THE GARDENS AT NORTH CAREFREE CONSTRUCTION DRAWINGS EL PASO COUNTY, STATE OF COLORADO

| GARDENS AT NORTH CAREFREE TITLE SHEET | |

| LINE # | LENGTH | START STA | END STA | DIRECTION | START POINT (EAST, NORTH) | END POINT (EAST, NORTH) |
|--------|--------|-----------|-----------|------------------|---------------------------|-------------------------|
| L201 | 10.00 | 201+86.29 | 201+96.29 | N3° 29' 05.68"W | (3599.46,5467.13) | (3598.85,5477.11) |

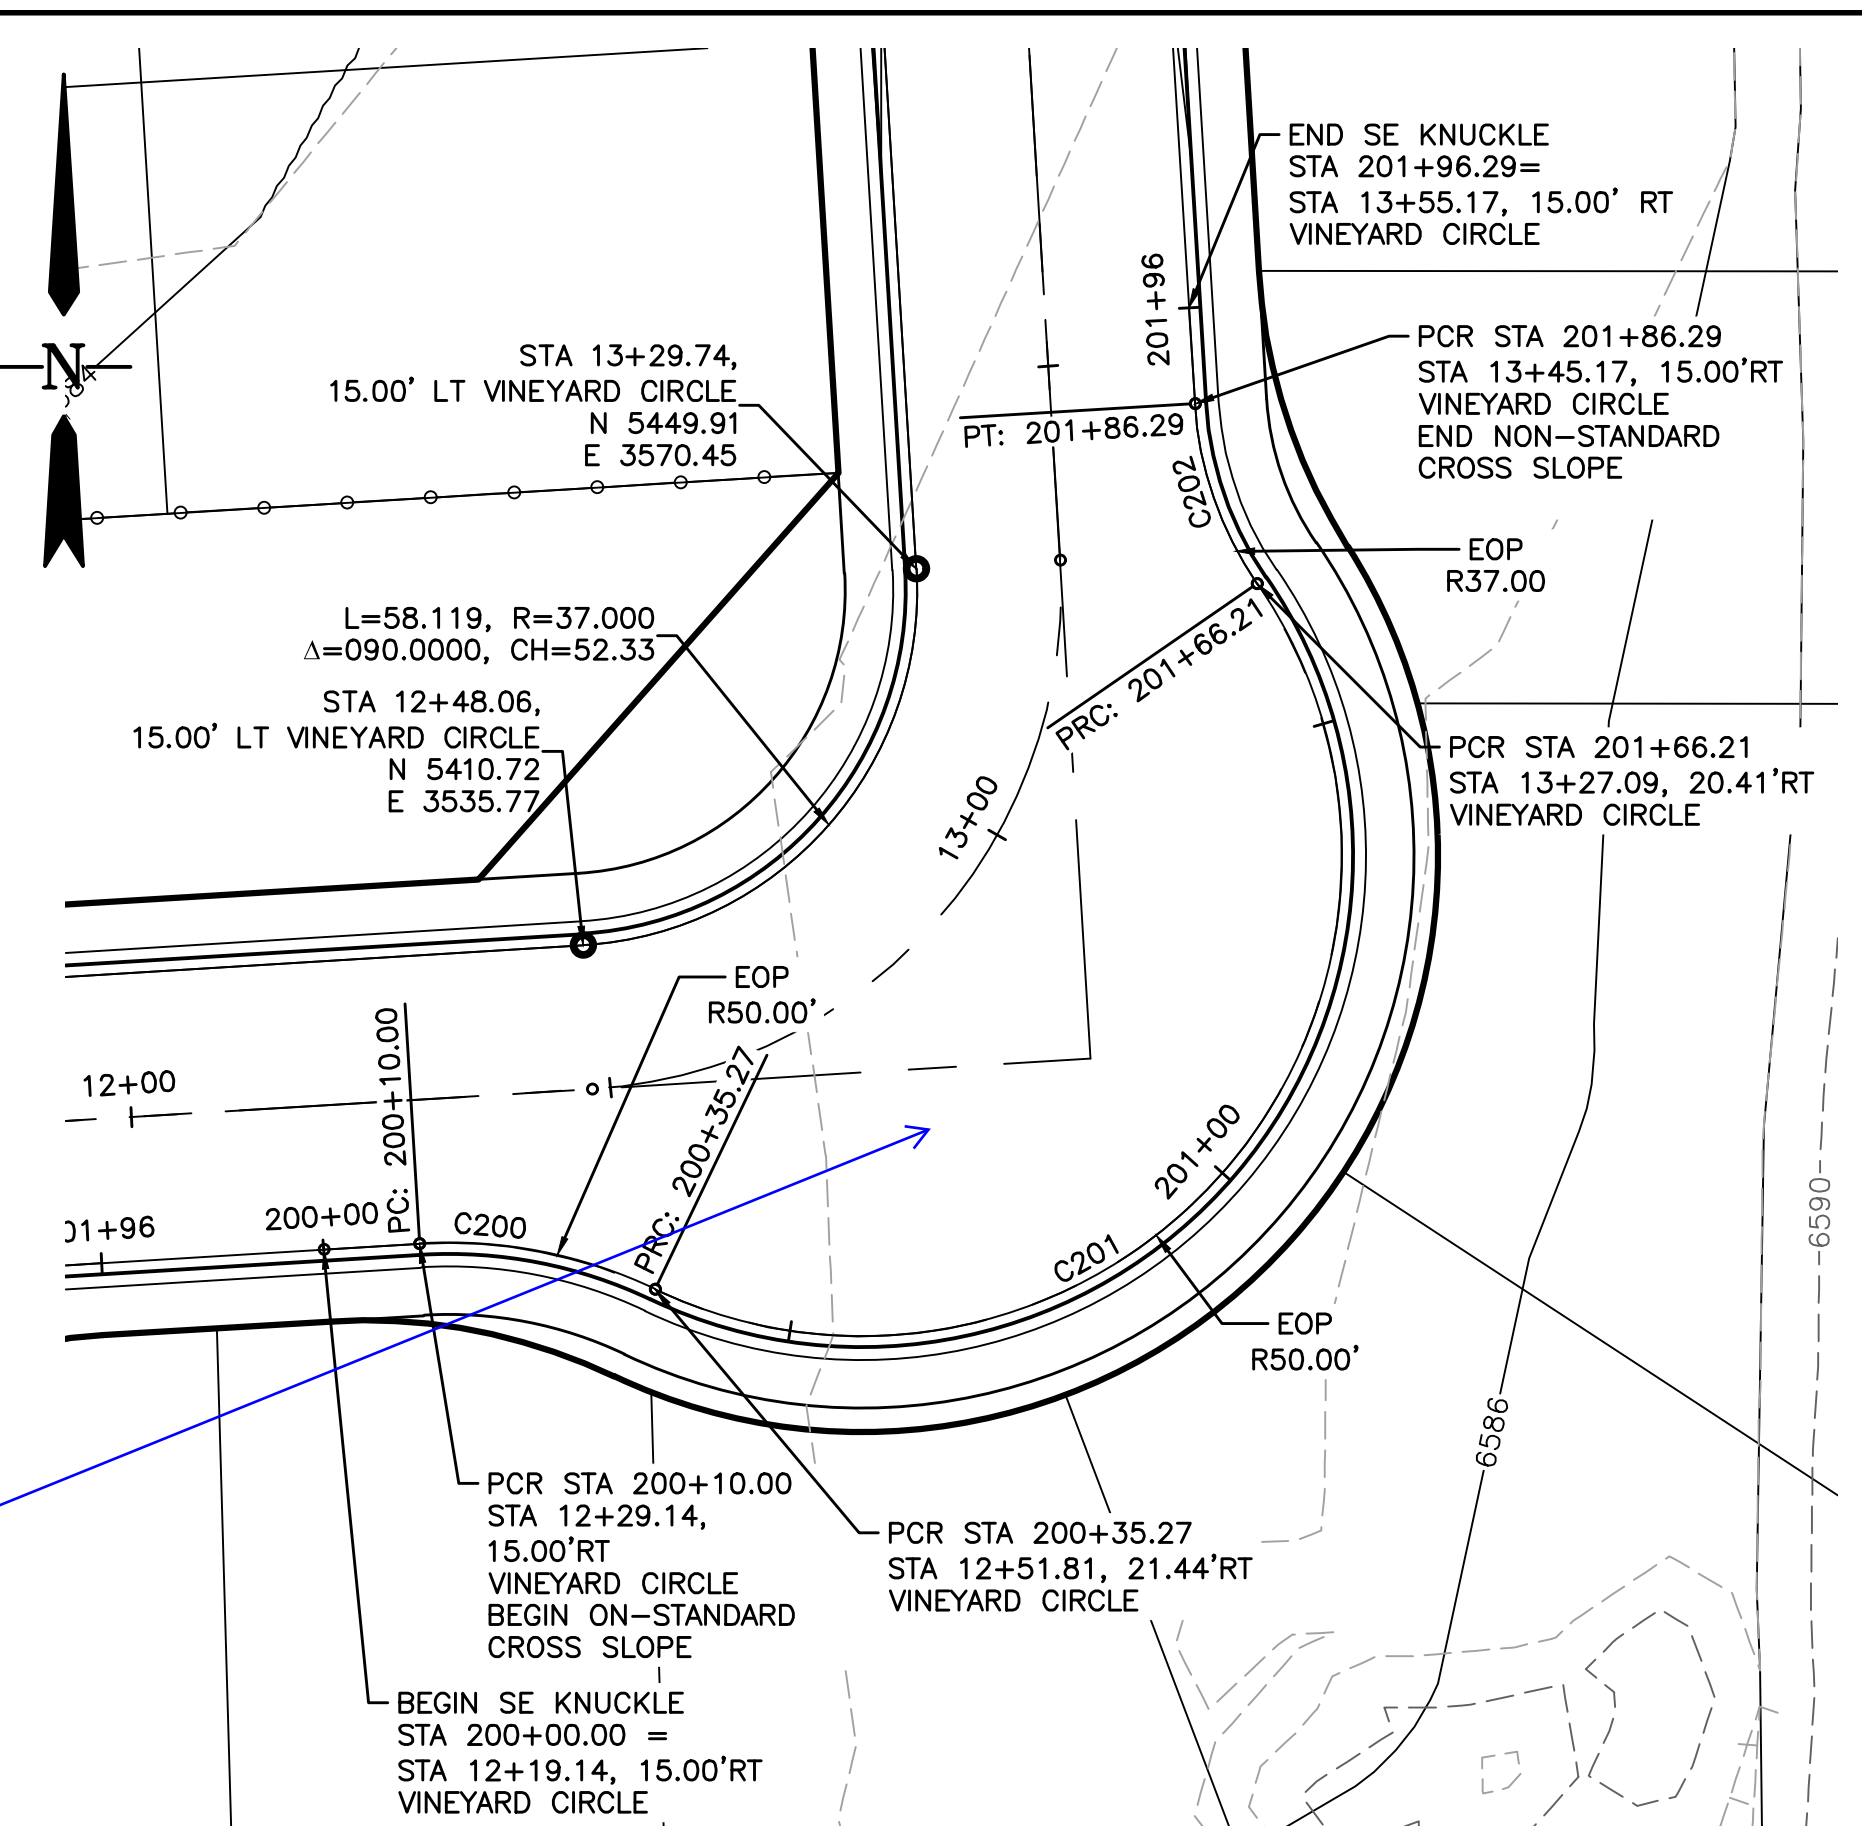
Please provide slope tags on this knuckle also.

THE GARDENS AT NORTH CAREFREE
PLAN AND PROFILE
CAREFREE SIDEWALK

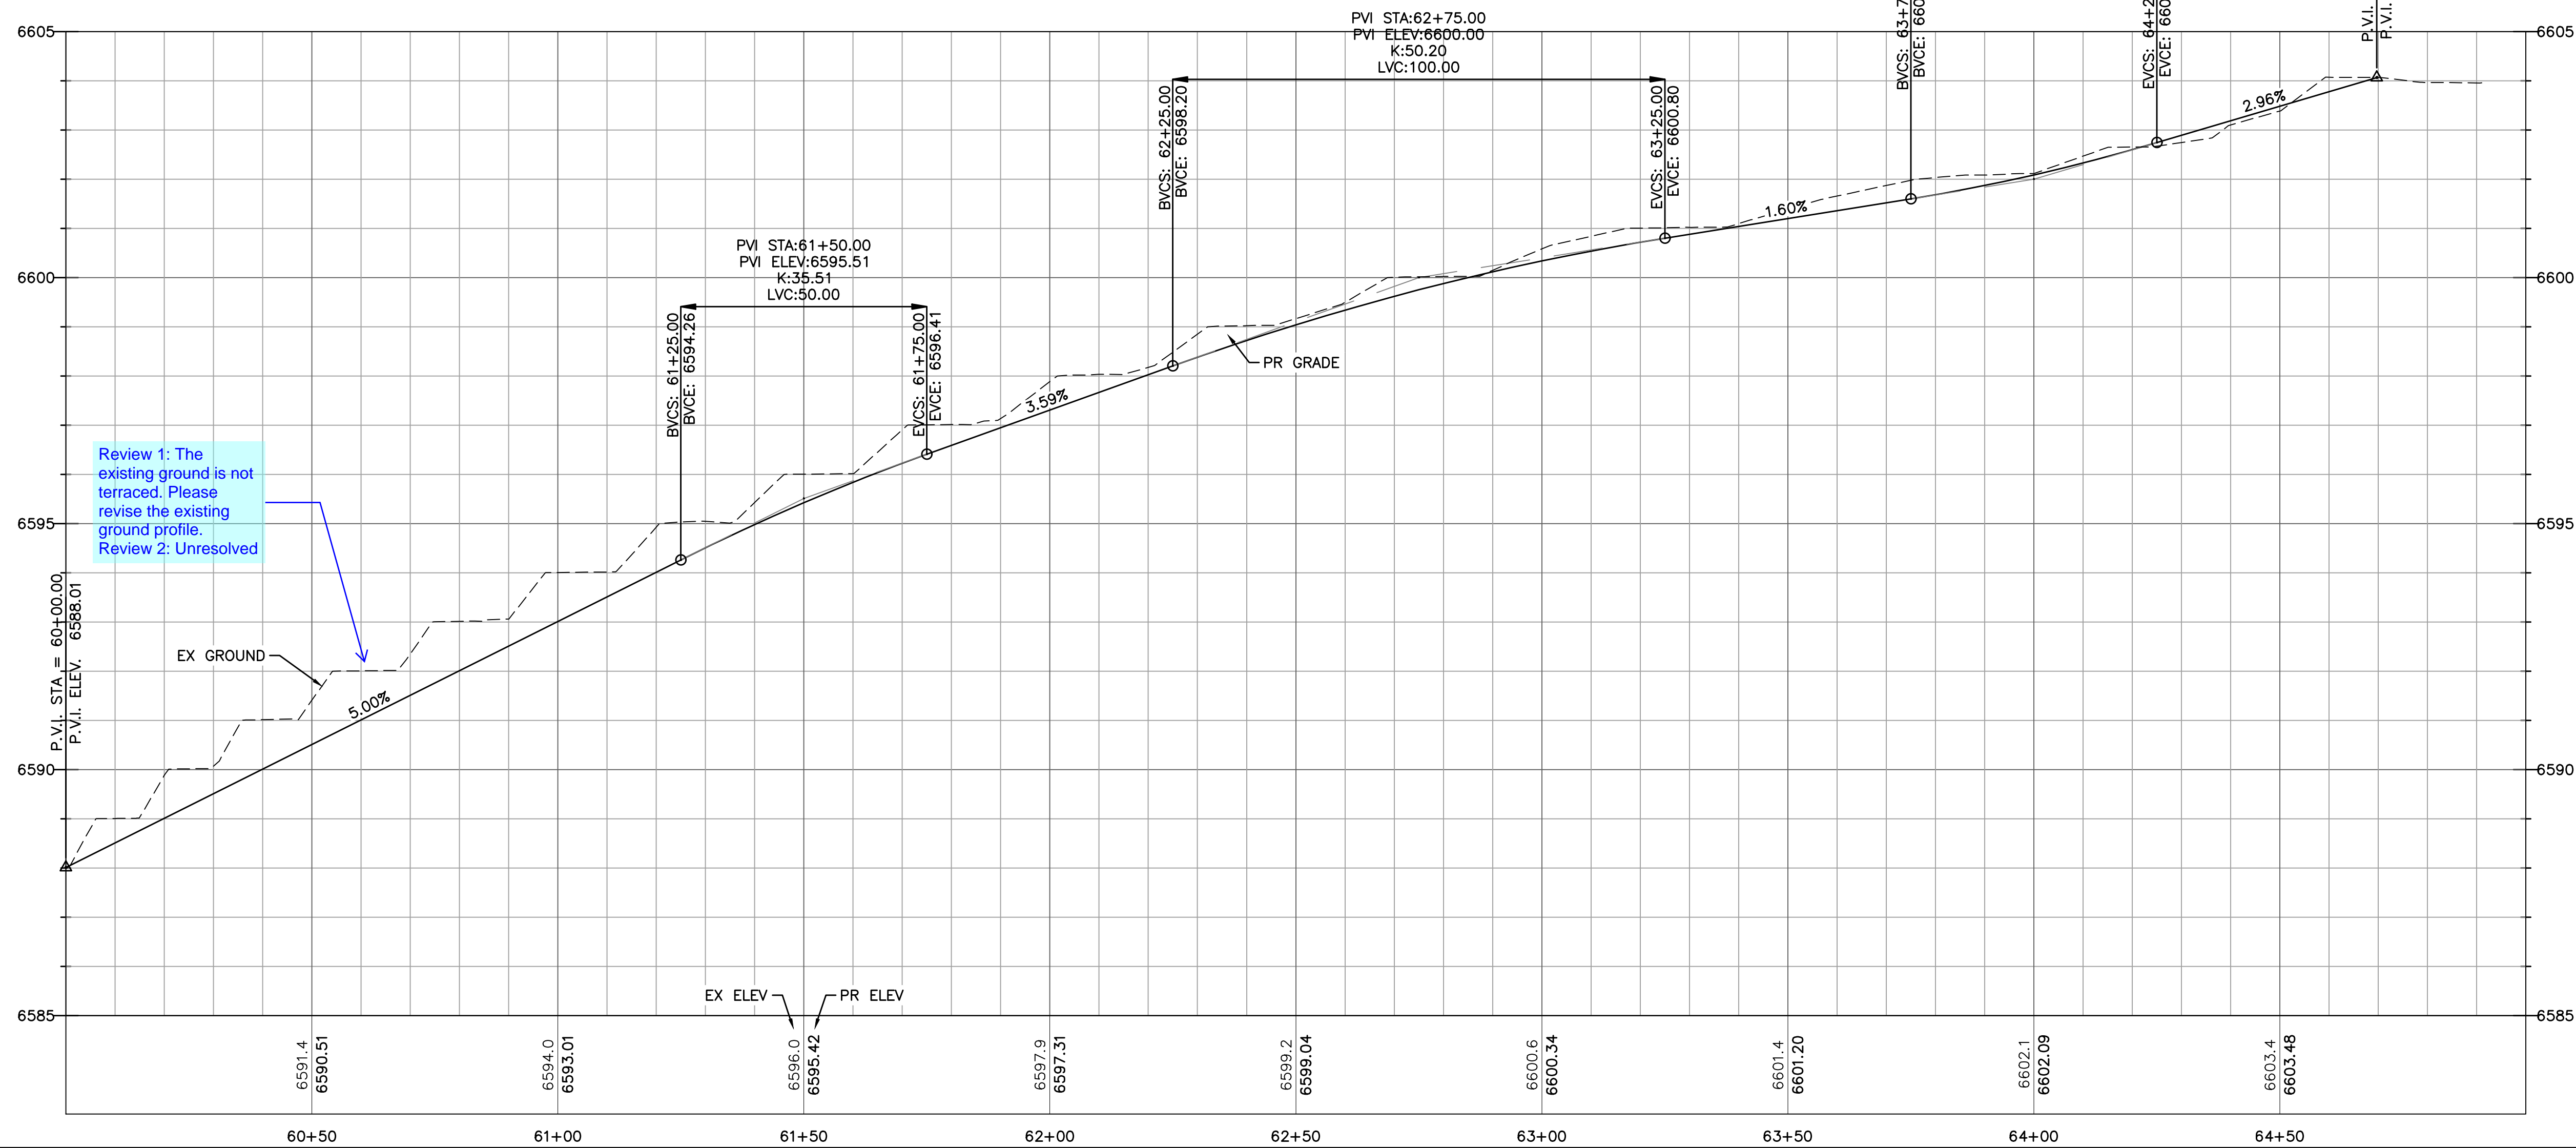
Review 1: The existing ground is not terraced. Please revise the existing ground profile.
 Review 2: Unresolved
